ALLOCATION PROBLEMS OF SECOND AND THIRD CHANNEL
FM RADIO STATIONS (LPFM) IN THE VICTORIA,
TEXAS, RADIO MARKET

SUBMITTED AS ADDENDUM TO REPLY COMMENTS
IN RM-9242
BEFORE THE
FEDERAL COMMUNICATIONS COMMISSION

ADDENDUM 21

EXHIBIT E.R.C. (7)

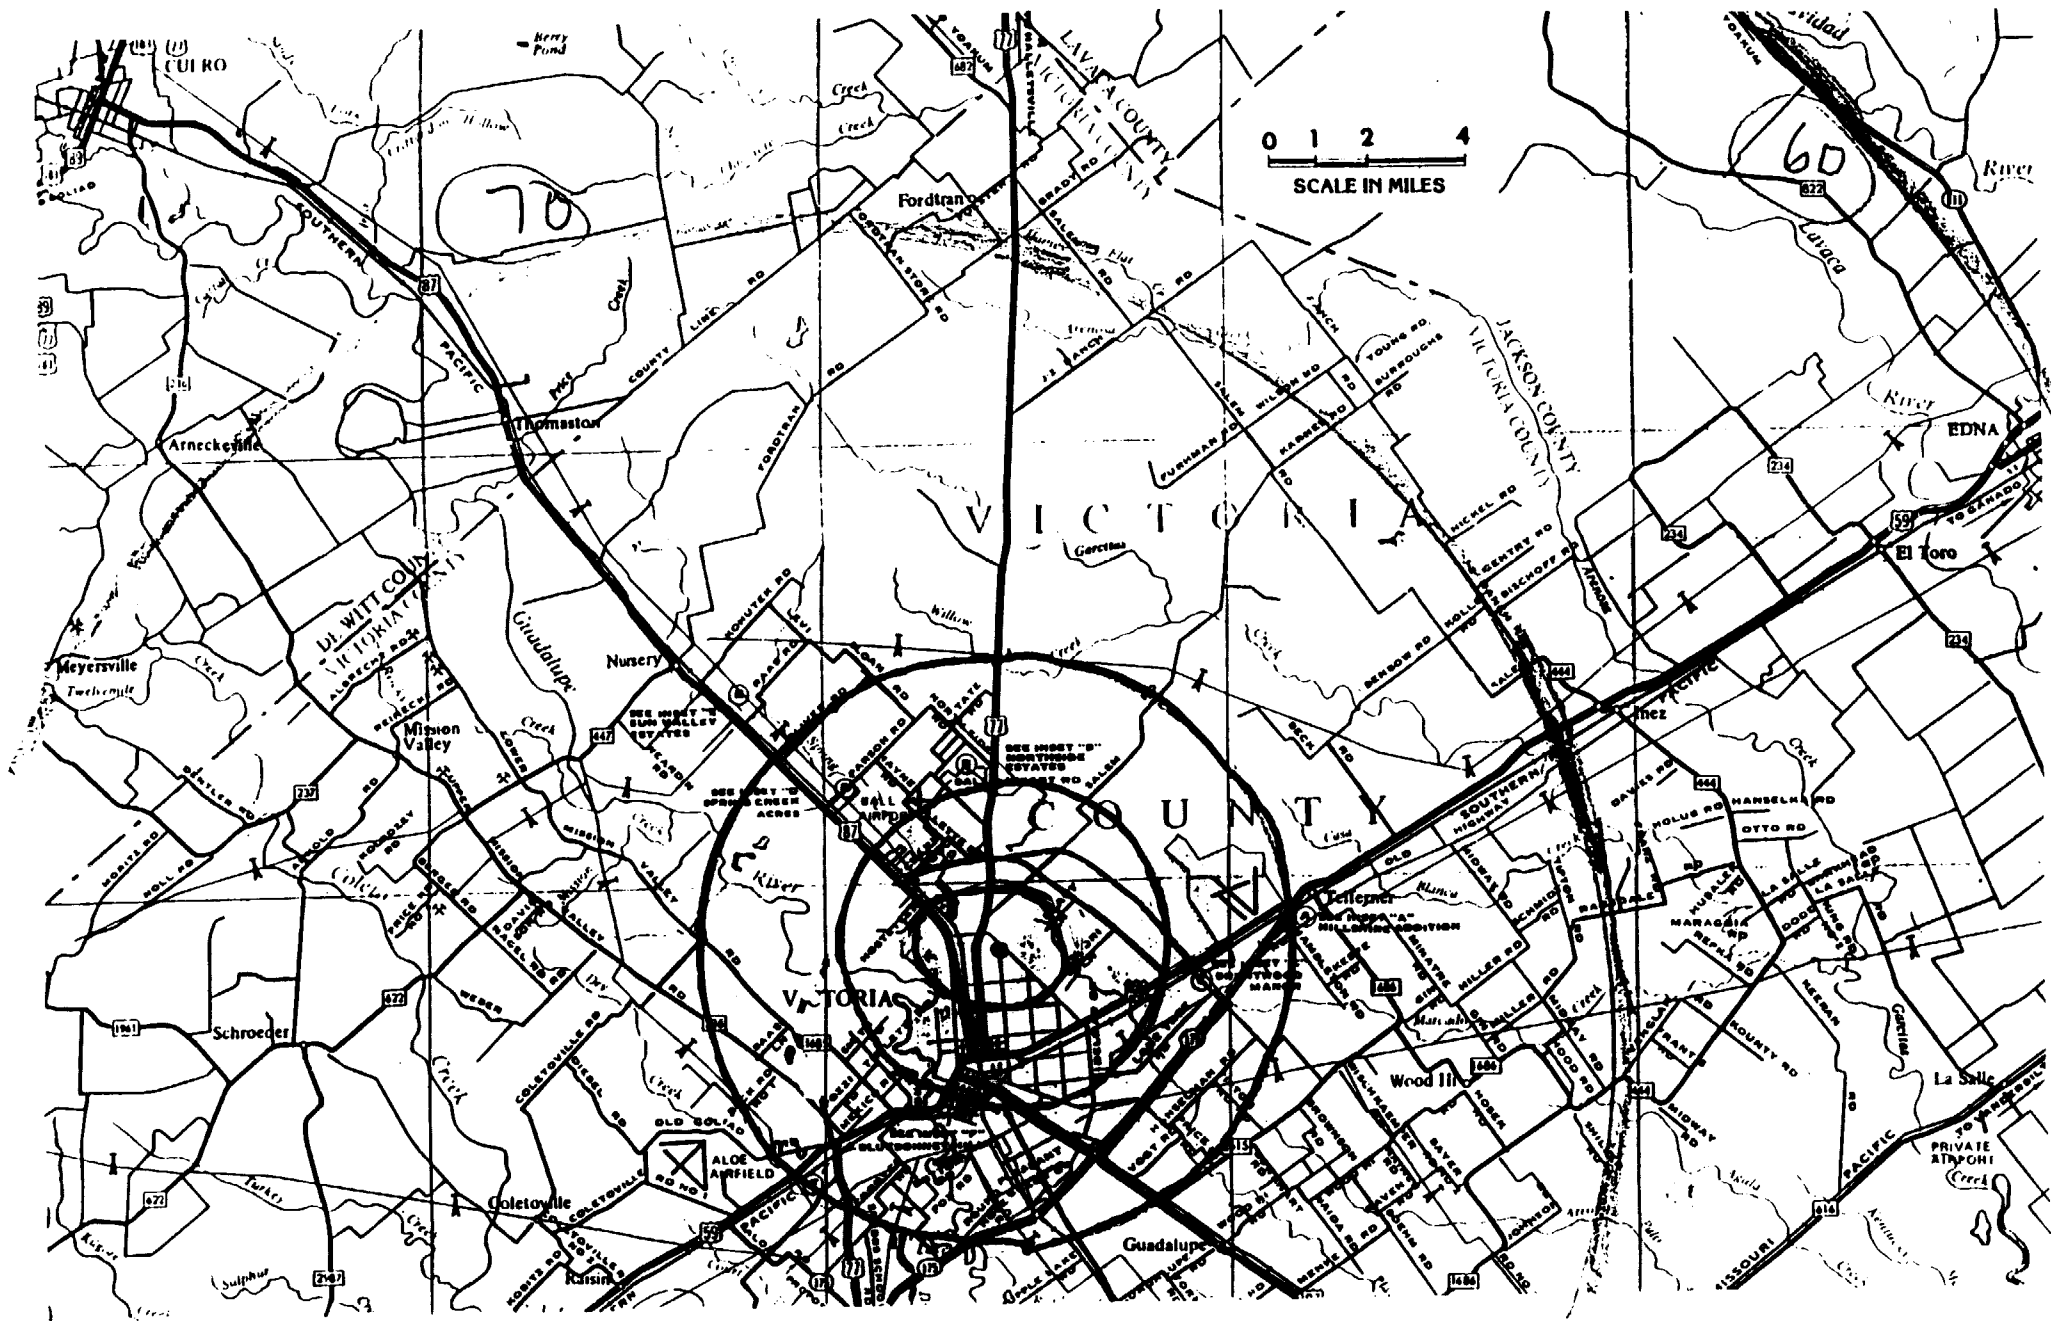
Norwest alternative LPFM 100 watts at 100 feet (32M) coverage contours of 80, 70, and 60 dbu within KTXN 70 and 60 dbu contours.

EXHIBIT (12)

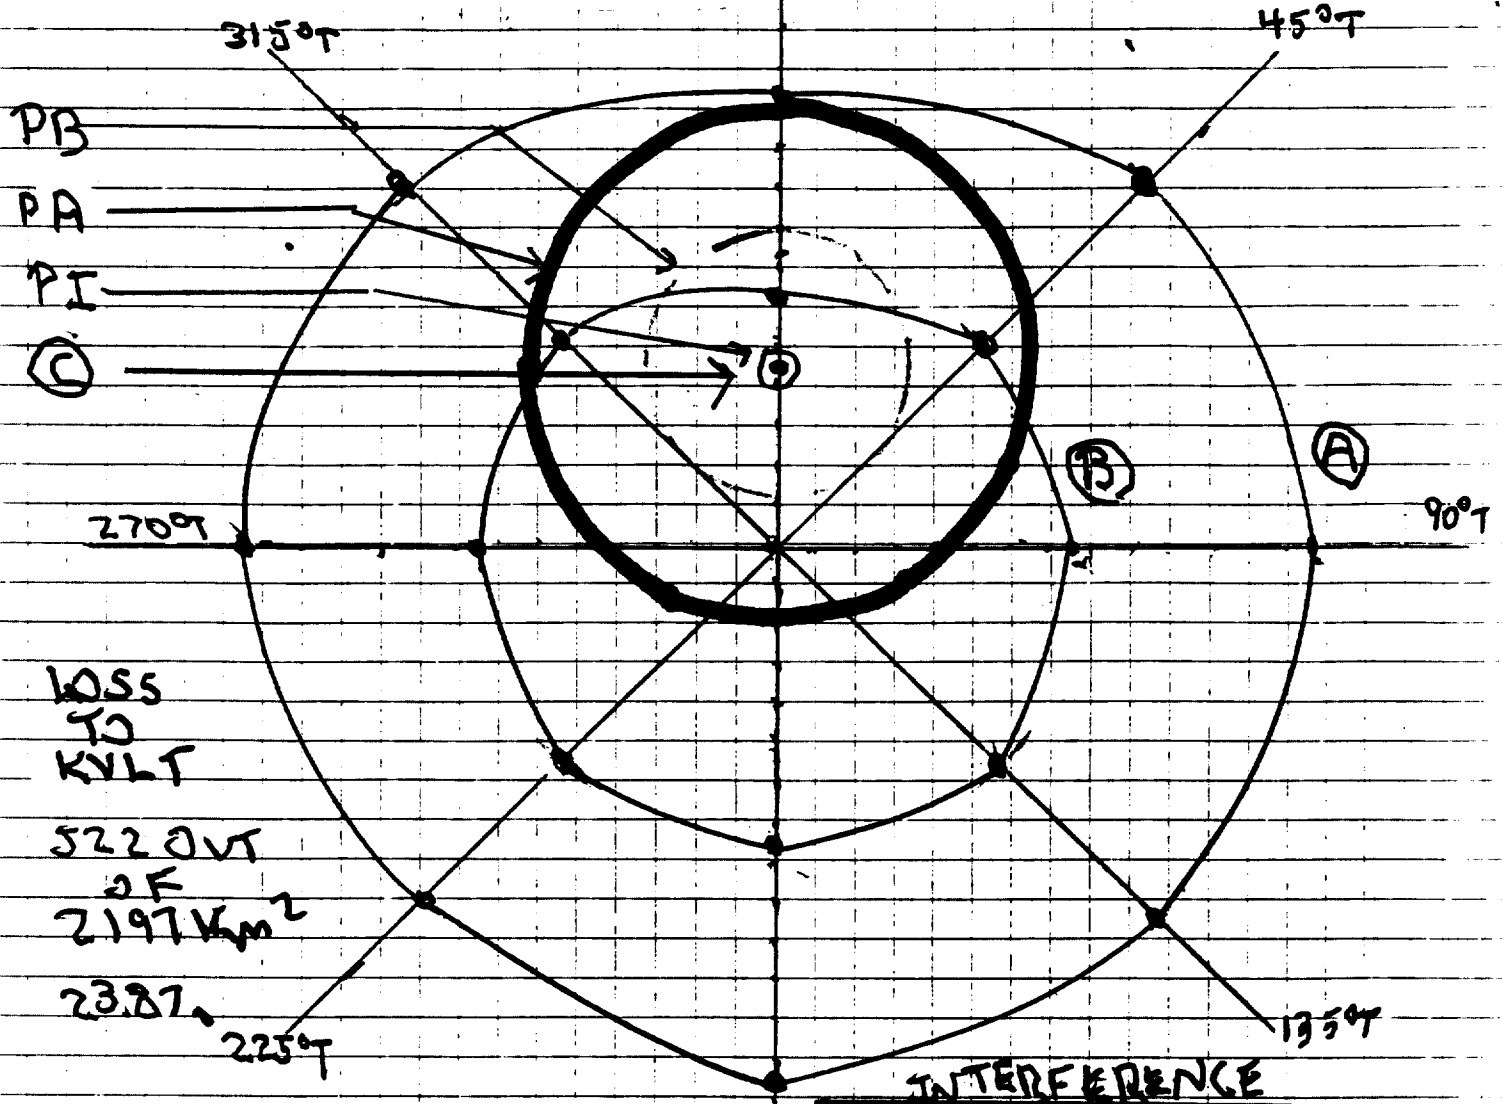
KVL T victim station interference from
Norwest proposed station. ± 600 kHz.

1000 T CONTOUR IS WITHIN
KVL T 60 DBU PROTECTED.
